Access Compliance Report

Public Rights-of-Way

Intersection ID: 31473	Main Street: ALSTON_HILL_DR	Cross Street: EMERALD_FERN_WY	Location: NW
ADA ID: DDFB631208B5	Ramp Type: PerpDiag	Initial Pass/Fail: Fail	Overall Compliance: No
		Severity Score: 8.75

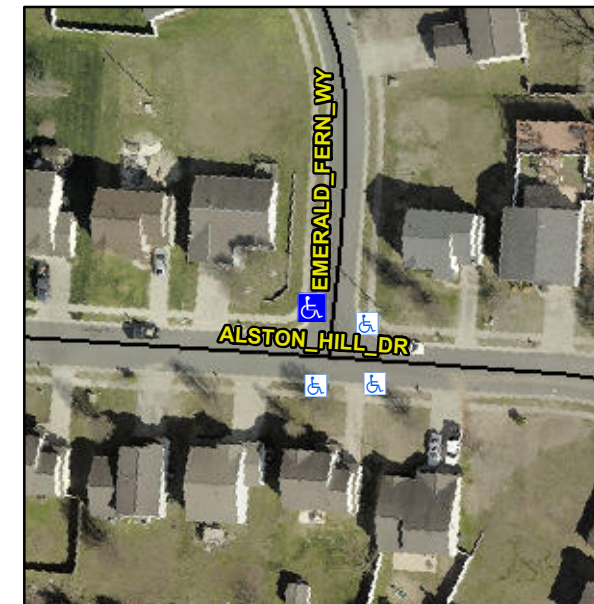
Remove & Replace Curb Ramp With Two New Directional Ramps or Equivalent.

R304.5.1
